**SLINGSHOT**

SERVICE BULLETIN

Release Date: October 14, 2022**Expiration Date:** December 31, 2023**SLI****Communication #:** T-22-01**Model Year(s):** 2020-2022

SUBJECT: OIL PRESSURE SWITCH**PURPOSE**

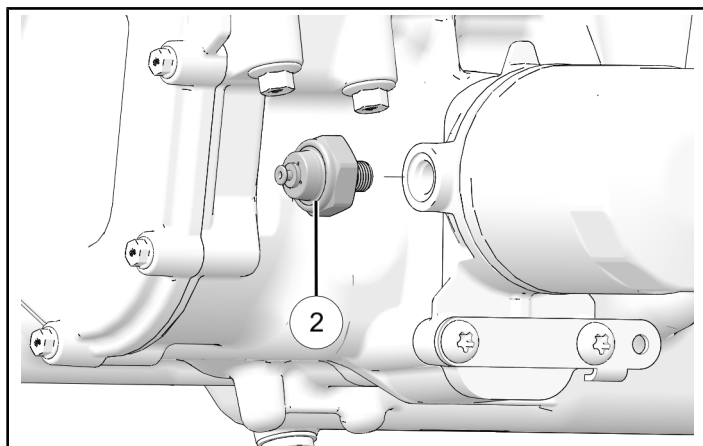
1. Park vehicle on a flat surface.
2. Apply parking brake.
3. Press START/STOP button to turn vehicle OFF.
4. Remove key fob from proximity of vehicle.
5. Open the hood.
6. Lift the front of the vehicle to gain access.
7. Place an oil drain pan under the vehicle to collect any oil draining while the oil pressure switch is removed.
8. Slide the end of the electrical connector ① up to disconnect from the oil pressure switch.

9. Remove the oil pressure switch ② and DISCARD.

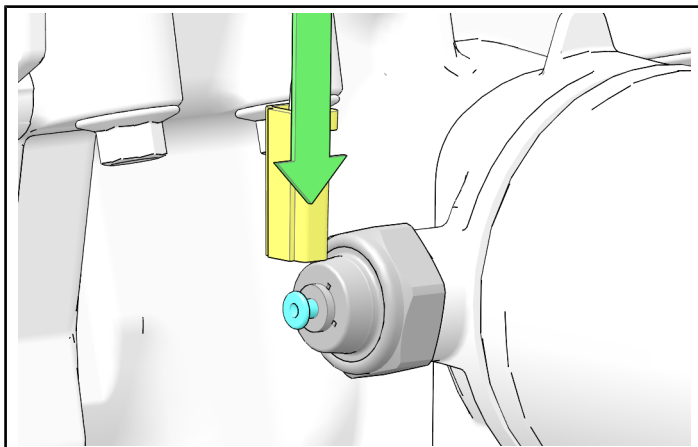
10. Install a **NEW** oil pressure switch. Torque to specification

TORQUE
Oil Pressure Switch: 89 in-lbs (10 N·m)
